Revision 02 - Section 96 Amendments

Site 68
Sydney Olympic Park

Elevation
West

Project No. S11611
Status s96 Application
Plot Date 23/6/2015 5:10 PM
Plot File S:\11600-11699\11611_ecove_sopsite68\00_main\cad\plots\A...
Drawing No. [Revision]

A05.02[02]

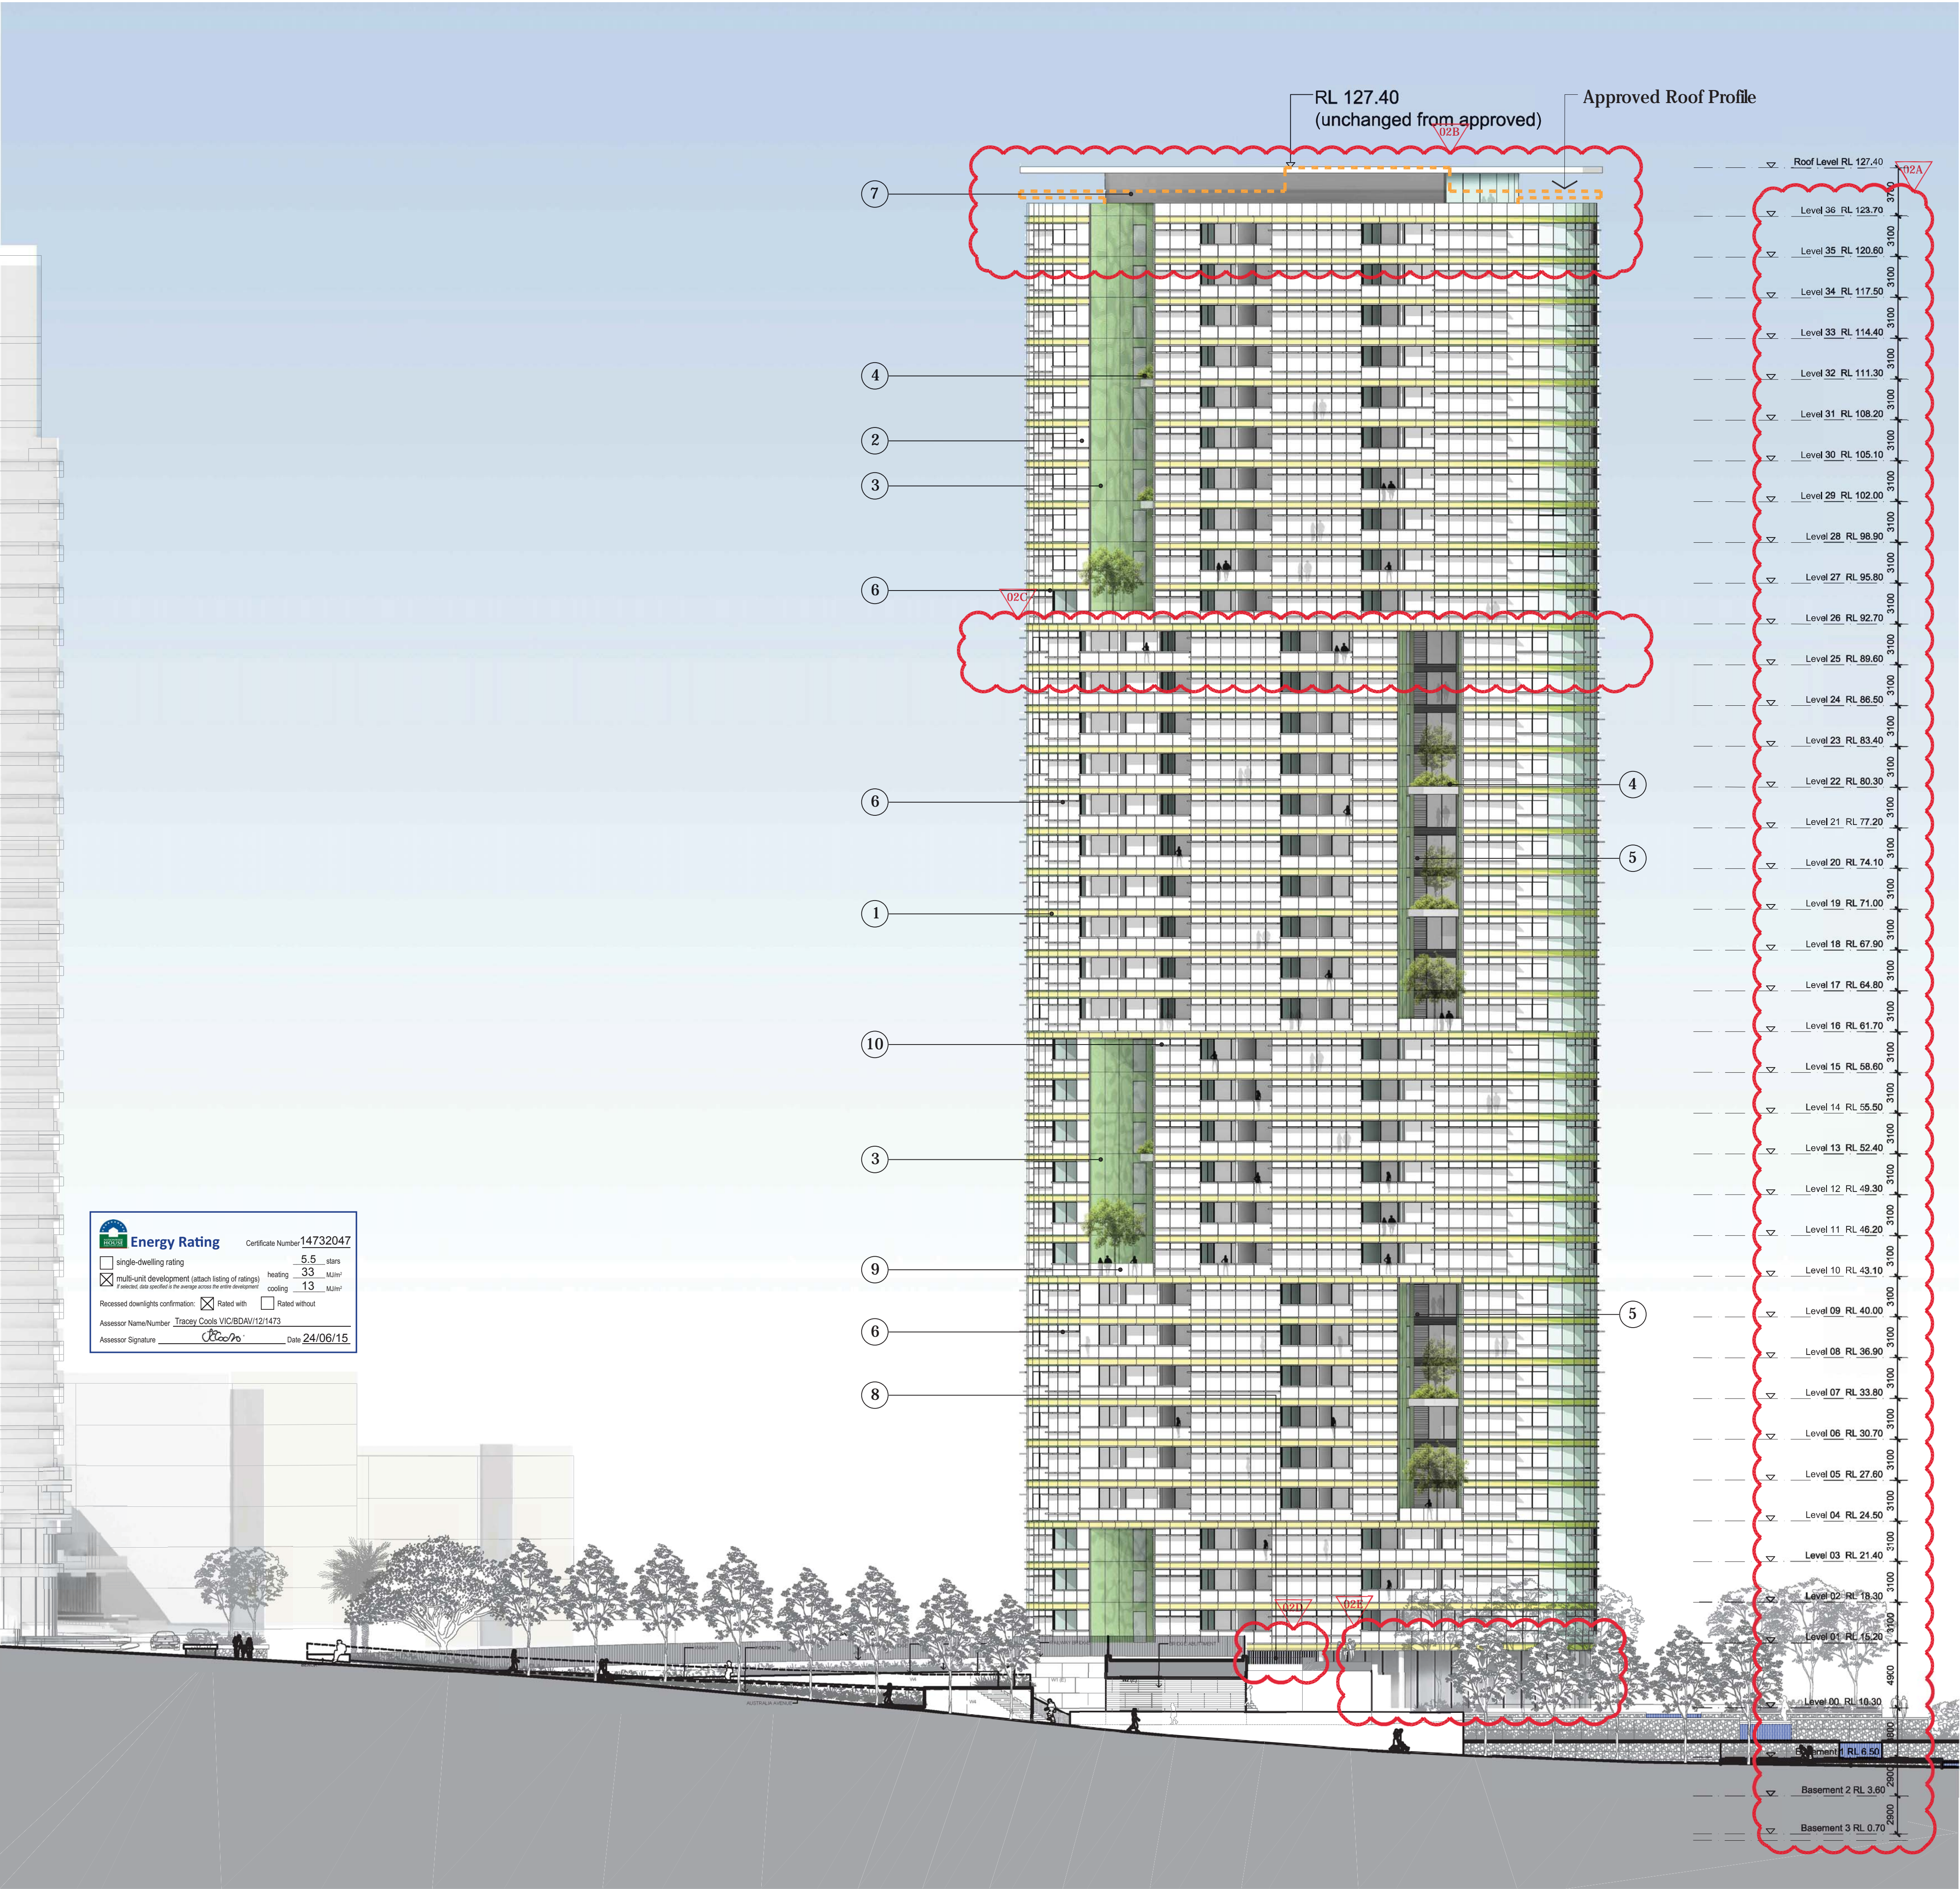
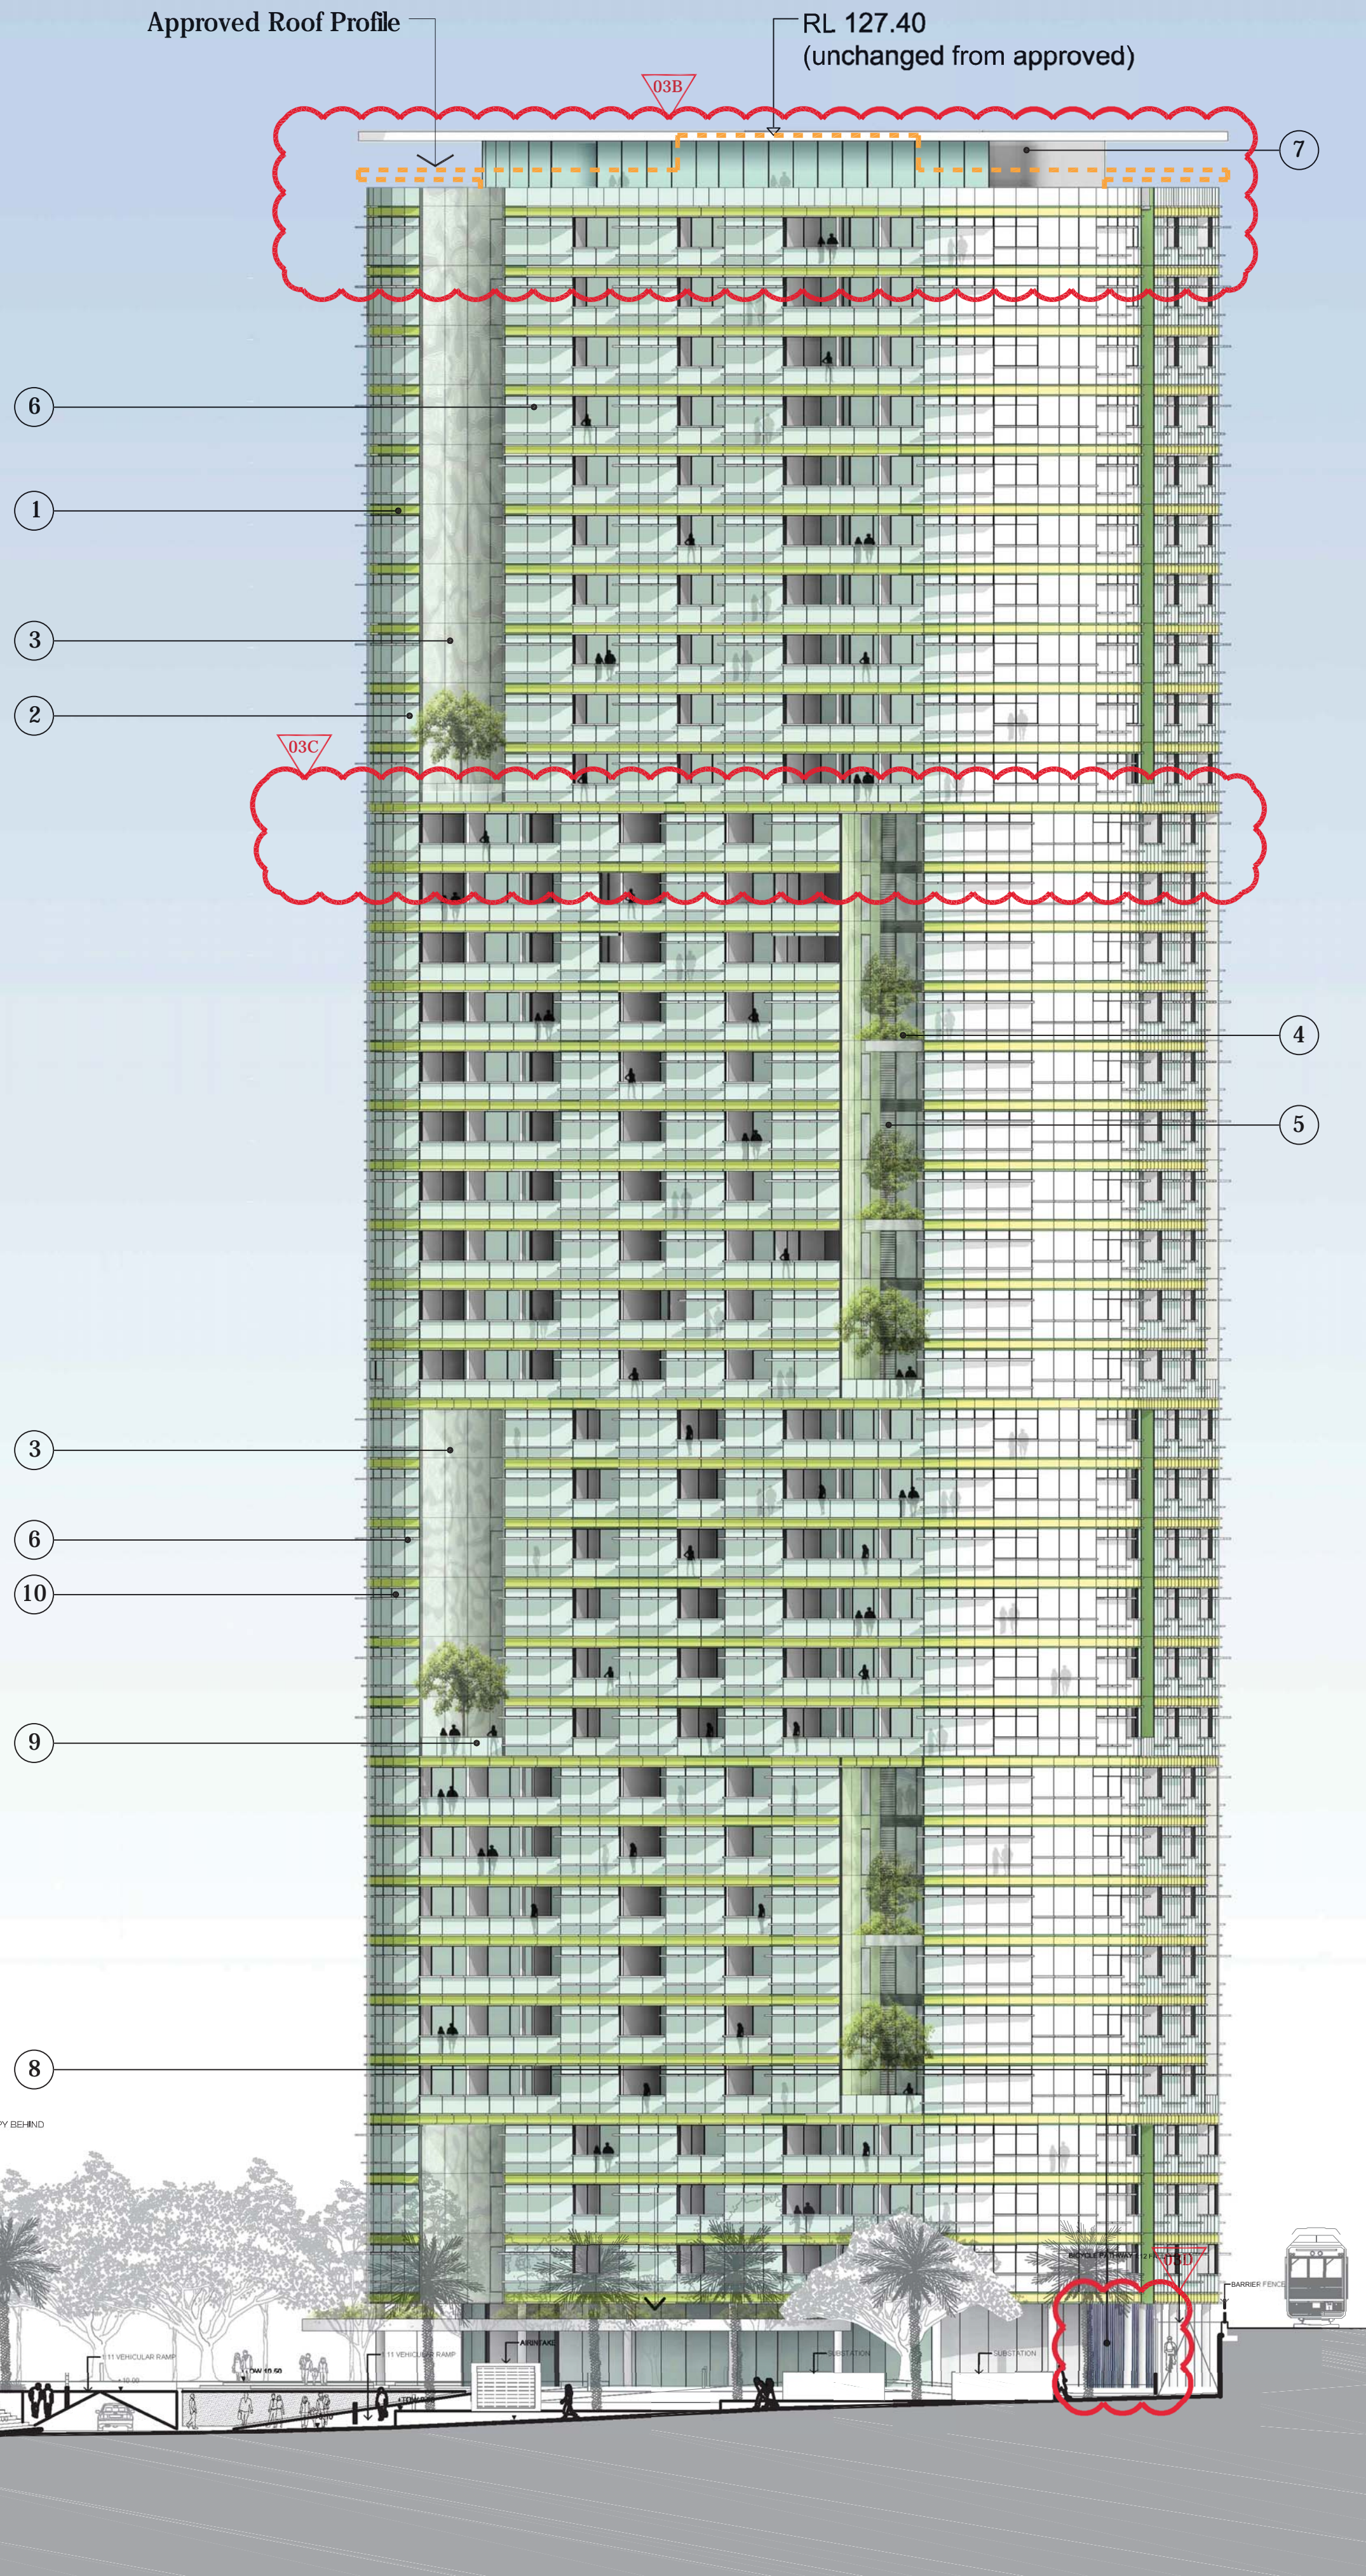
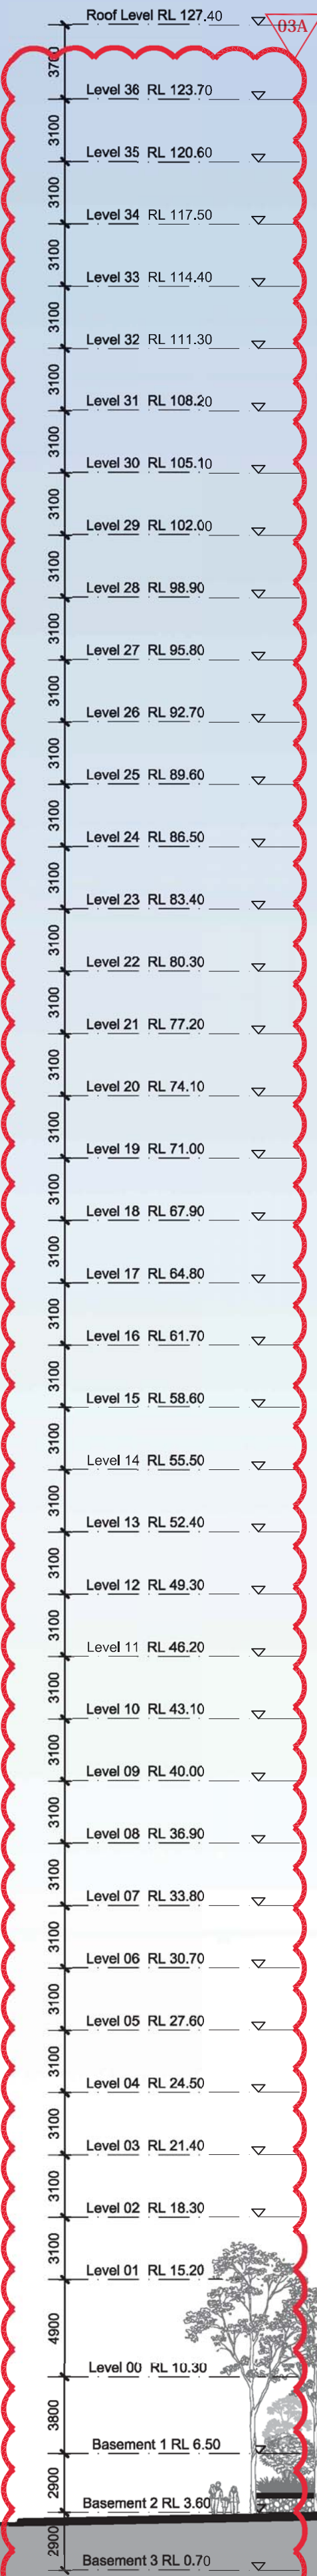
A - Revision to landscape levels. Tower lobby FFL lowered from 10.70 to 10.30. Tower typical floor to floor height levels reduces from 3.2m to 3.1m.

B - Excess plant space on rooftop converted to residential flats. New floor inserted at Level 35.

C - New typical floor inserted at level 25.

D - Material change to vertical aluminium profile.

E - New retail tenancy within existing footprint at grade.

A05.03[03]

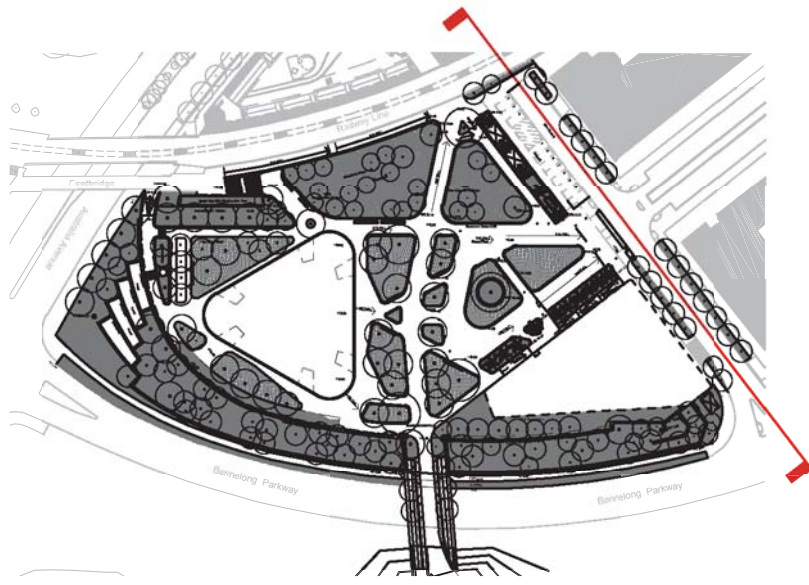
- A - Revision to landscape levels. Tower lobby FFL lowered from 10.70 to 10.30. Tower typical floor to floor height levels reduces from 3.2m to 3.10m.
- B - Excess plant space on rooftop converted to residential flats. New floor inserted at Level 35.
- C - New typical floor inserted at level 25.
- D - Material change to vertical aluminium profile.
